Revised Summary of Comments and Responses

Statewide Clean Water Act Section 303(d) List Portion
of the 2020-2022 California Integrated Report

Finalized date:
February 16, 2022

STATE WATER RESOURCES CONTROL BOARD
CALIFORNIA ENVIRONMENTAL PROTECTION AGENCY

Figure 3-6: A 4-Panel Plot Highlighting Reference Site Relative Influence with Key Environmental Gradients for Marsh Creek (Marsh Creek Reservoir to San Joaquin River; partly in Delta Waterways, western portion)

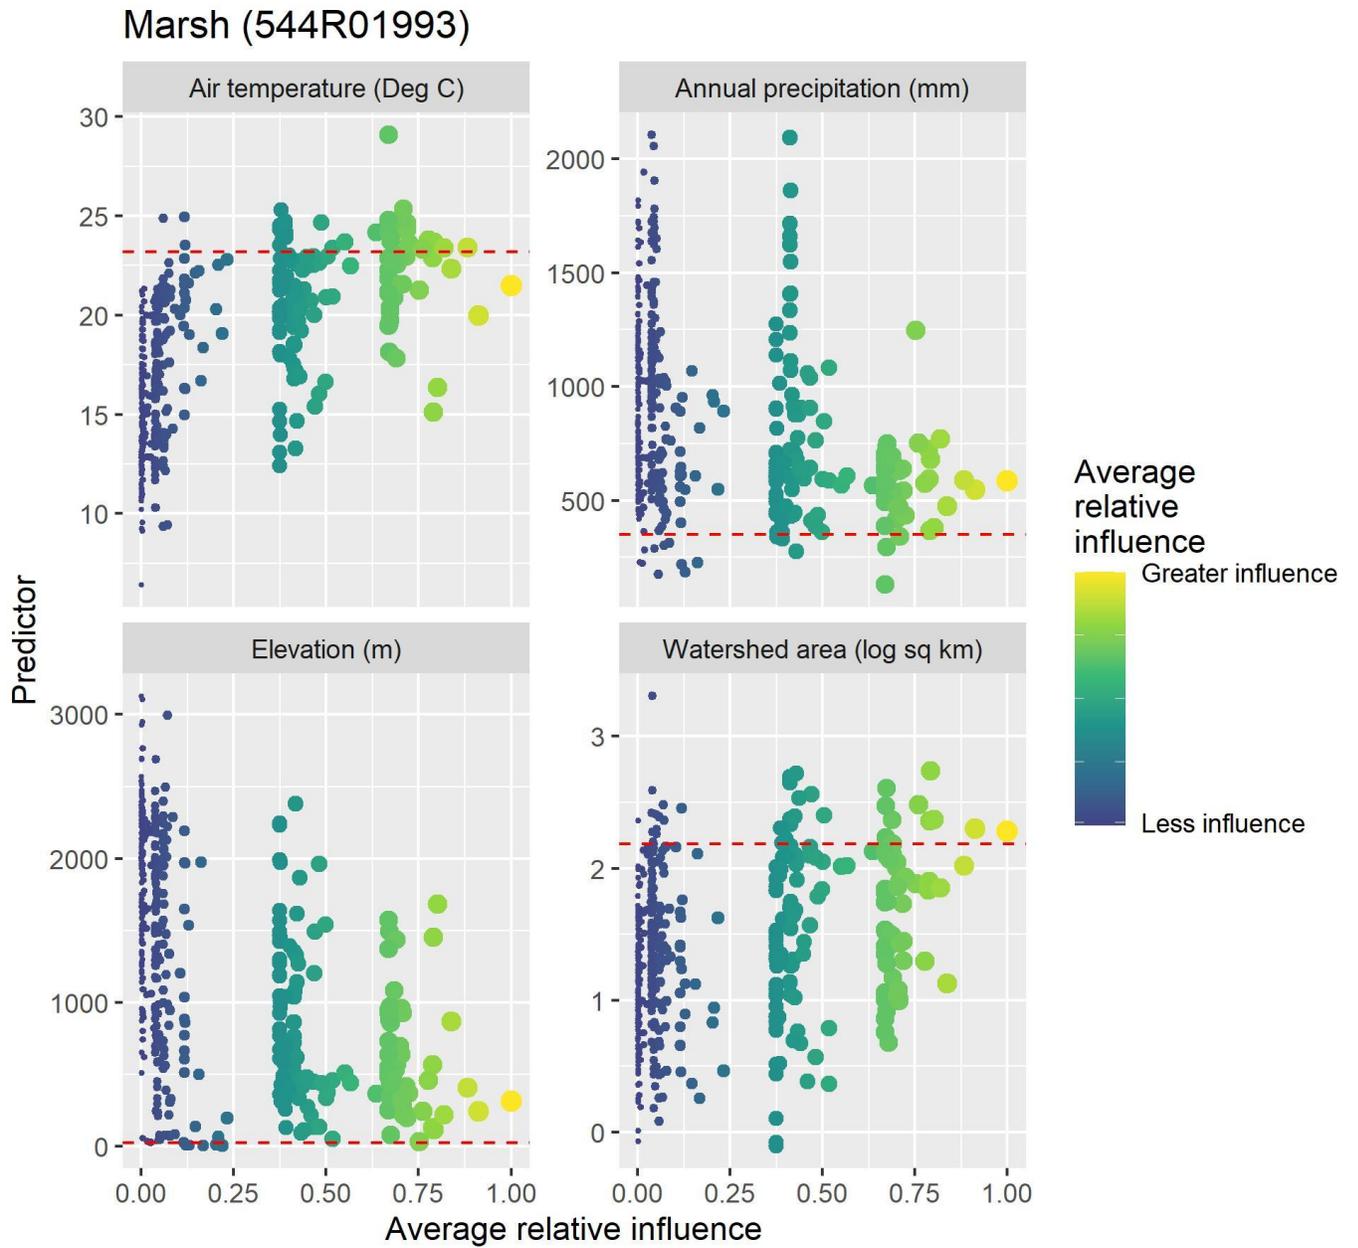
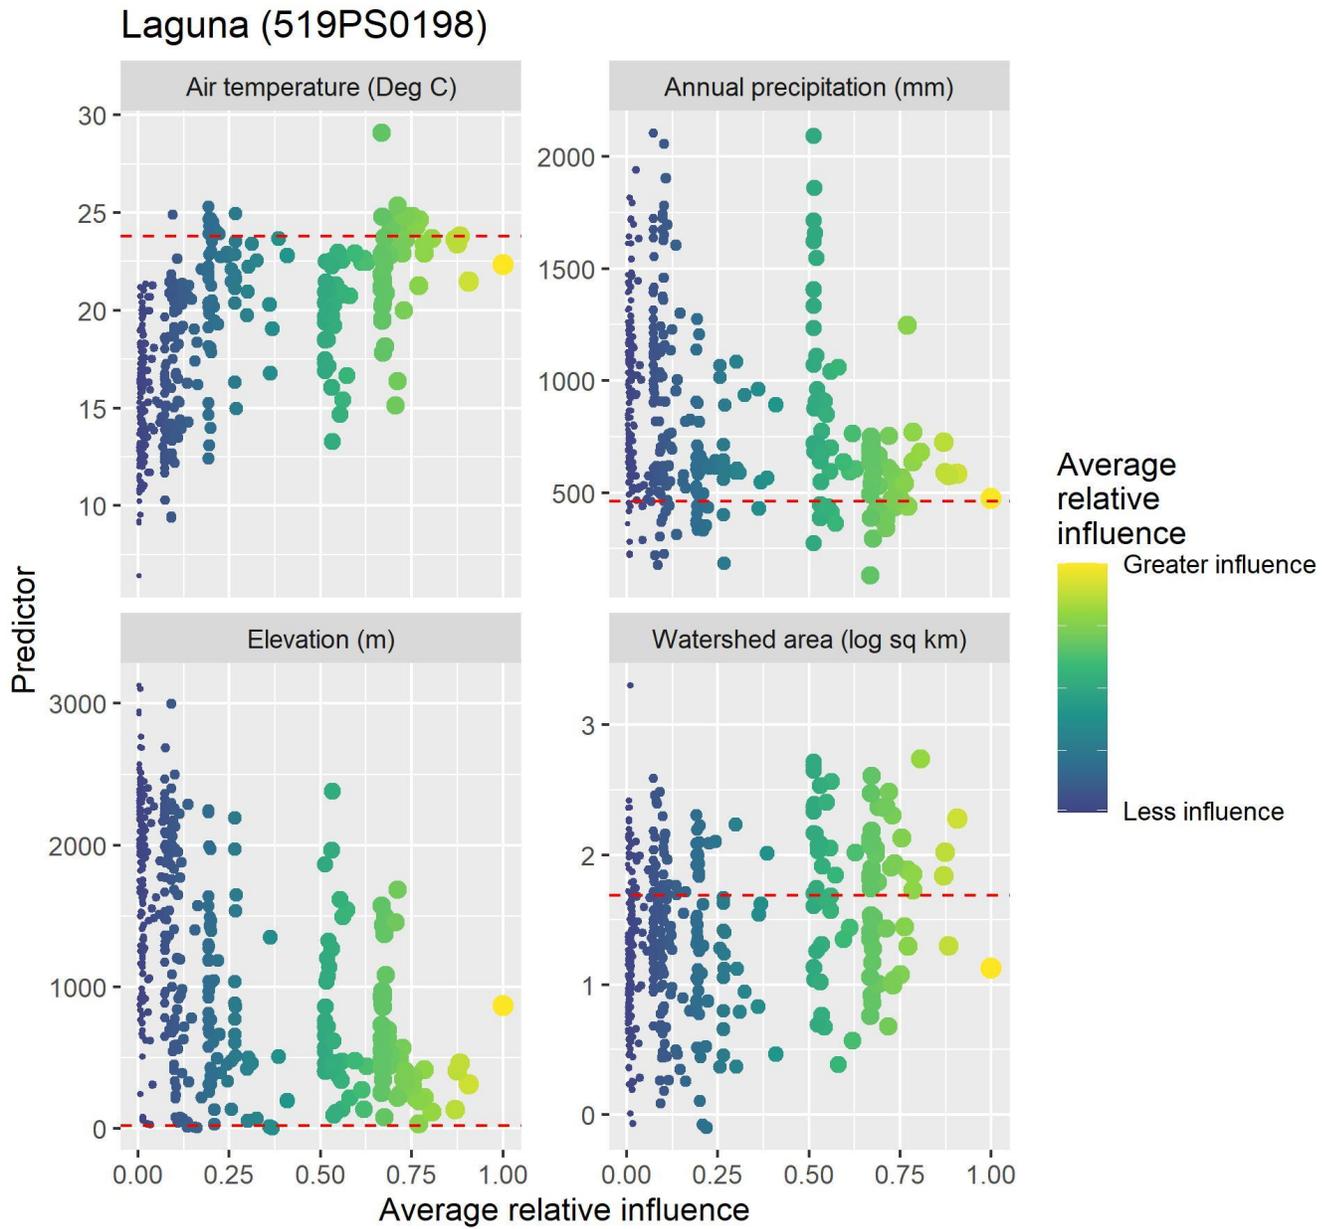
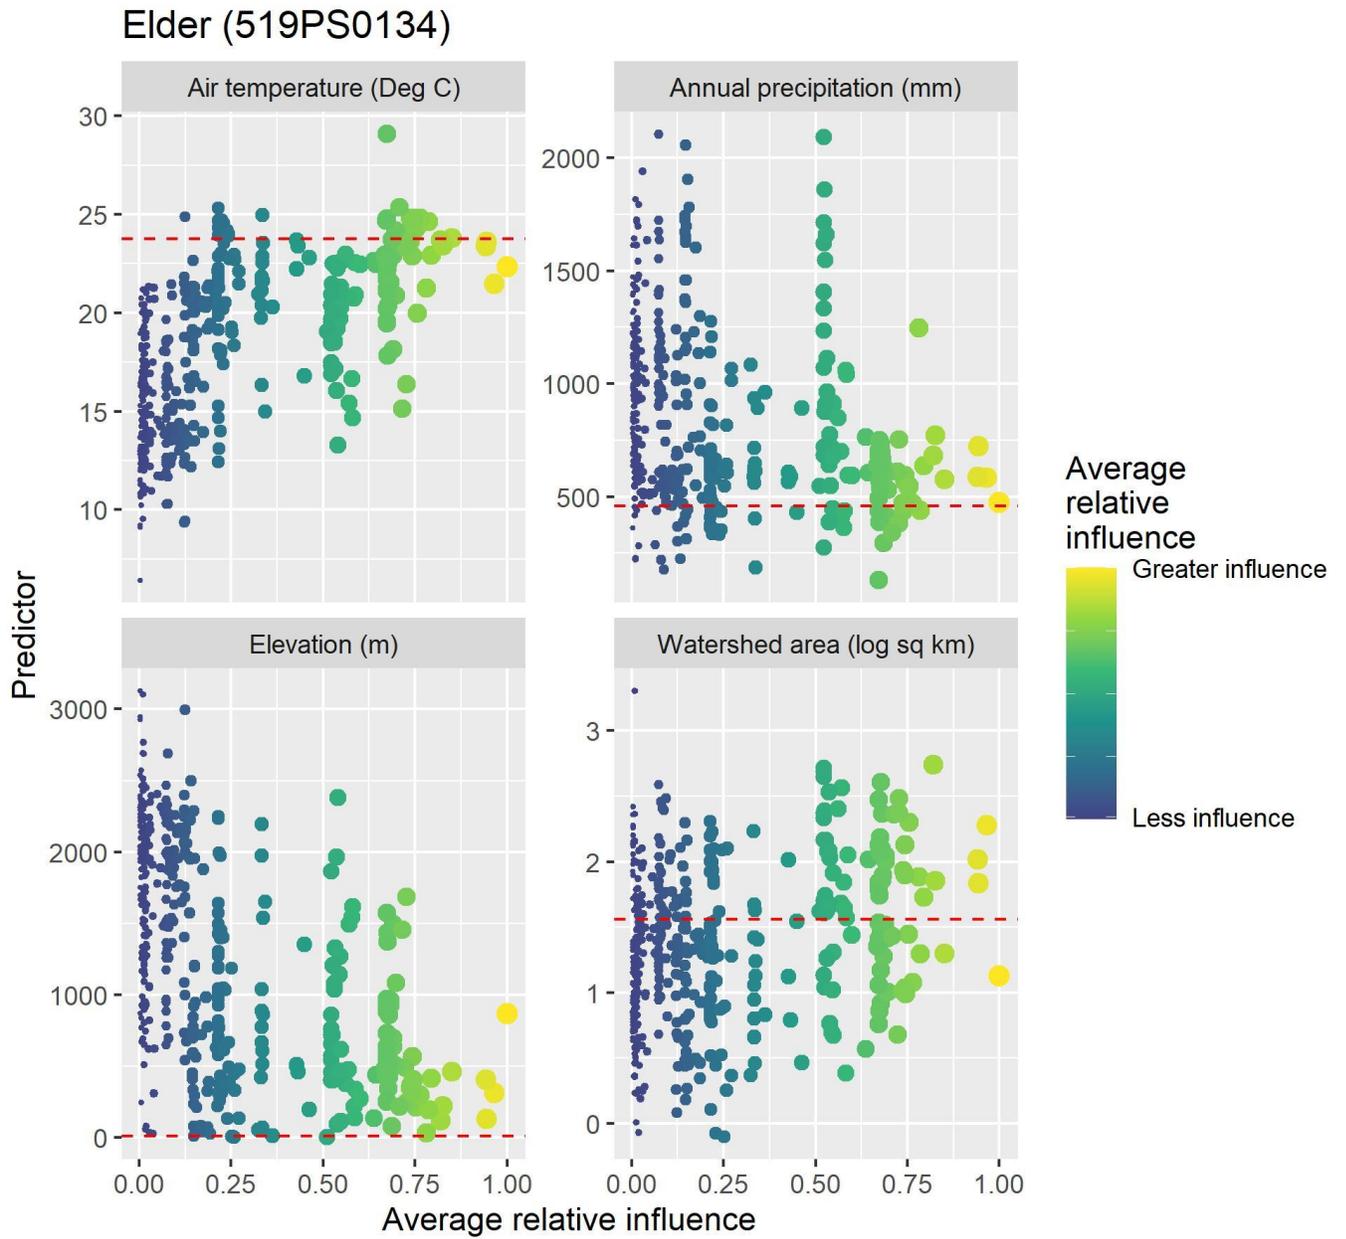
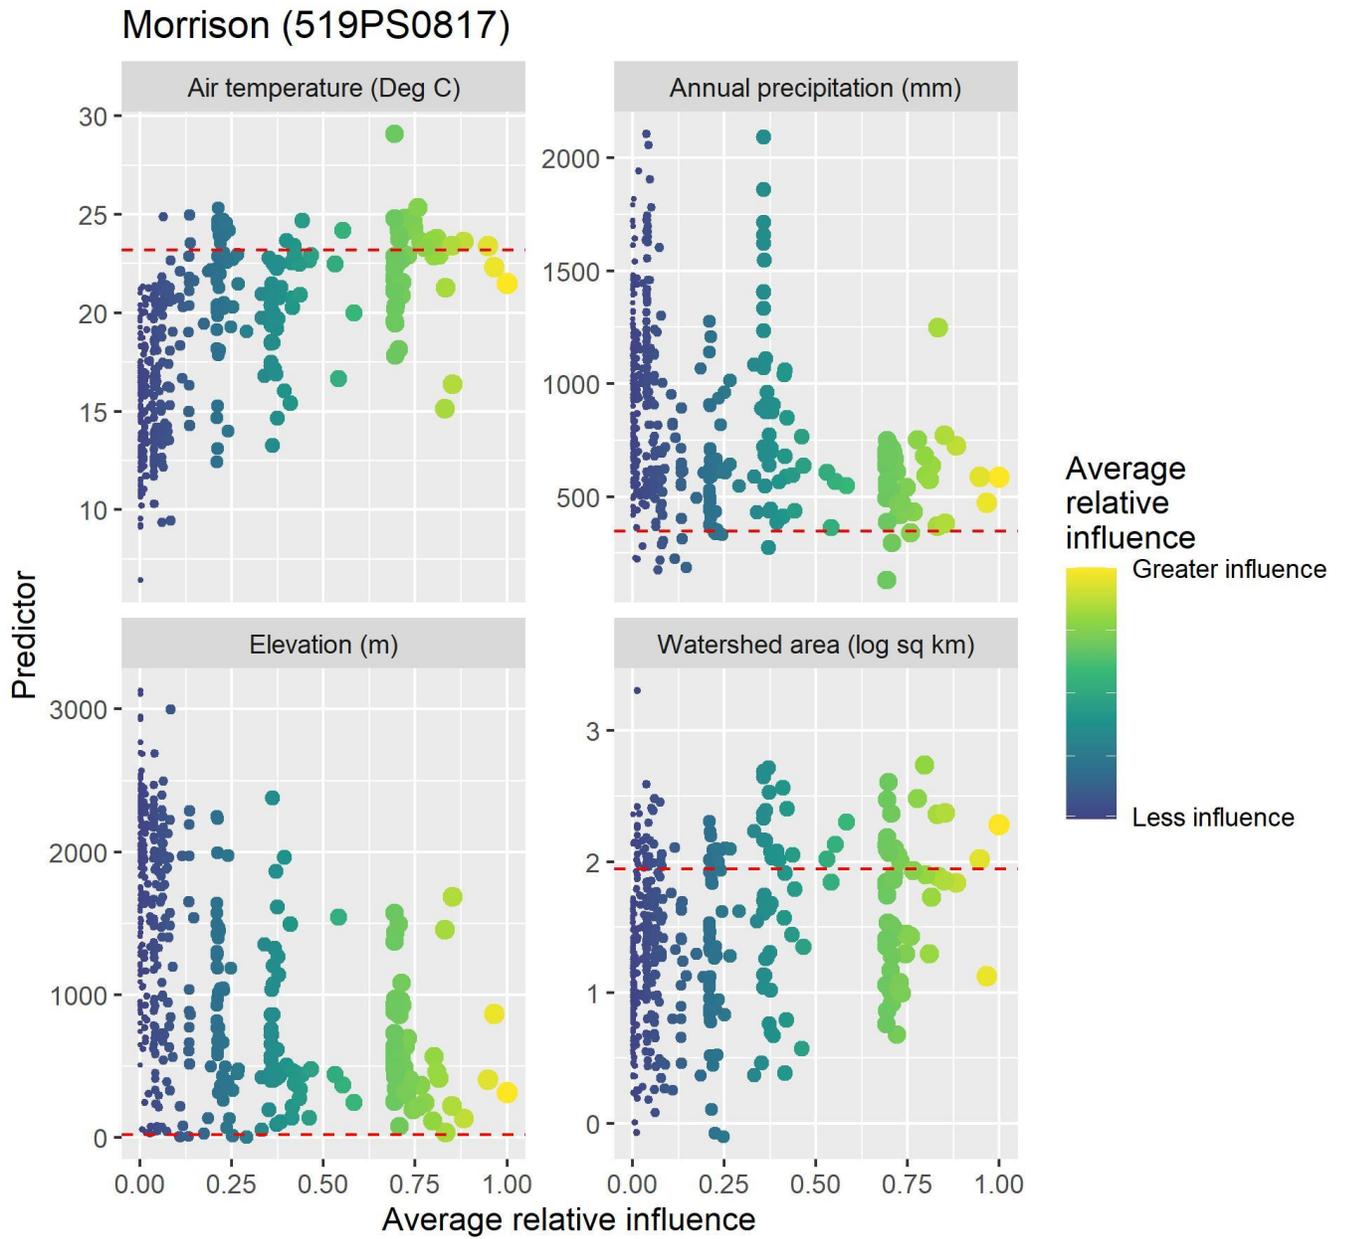
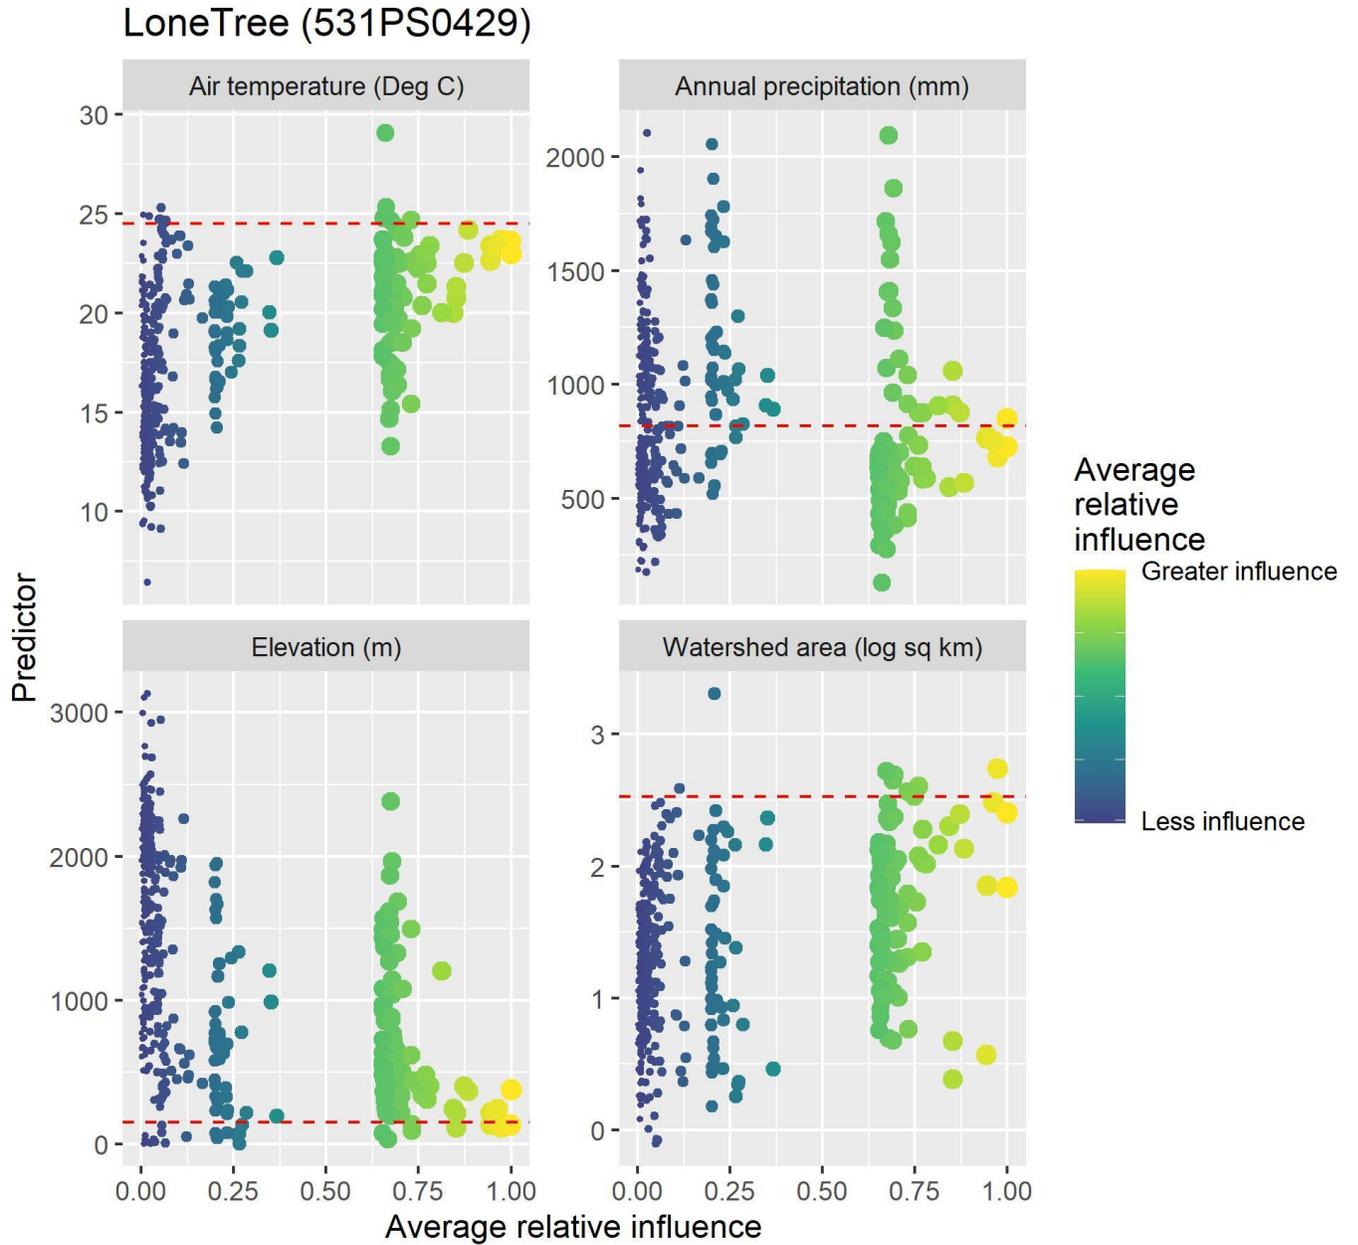
Changes to listing recommendations were not made in response to these comments. Even without a reference site located in the Central Valley floor, use of the CSCI threshold of 0.79 and its pool of reference sites is appropriate for assessing benthic community data for the five Central Valley floor waterbodies for the following reasons.

The following series of graphics (Figures 3-6 through Figure 3-10) show the influence of reference sites throughout California to each of the five Central Valley floor waterbodies in terms of annual mean air temperature, annual precipitation, elevation, and watershed area. These are key environmental settings with a high degree of influence on expected benthic community composition. Other environmental variables used to calculate CSCI scores include, but not presented in the figures below, elevation range, average bulk soil density, and average soil erodibility factor for catchment morphology (including stream gradient), geology, and climate considerations.

For example, the Marsh Creek site air temperature graph shows that there is one site (one yellow dot) with the greatest influence to Marsh Creek, several sites (the green dots) with greater influence, and many other sites (the blue-green and blue dots) with less influence. There are several reference sites in California with similar environmental settings as the five Central Valley floor waterbodies.
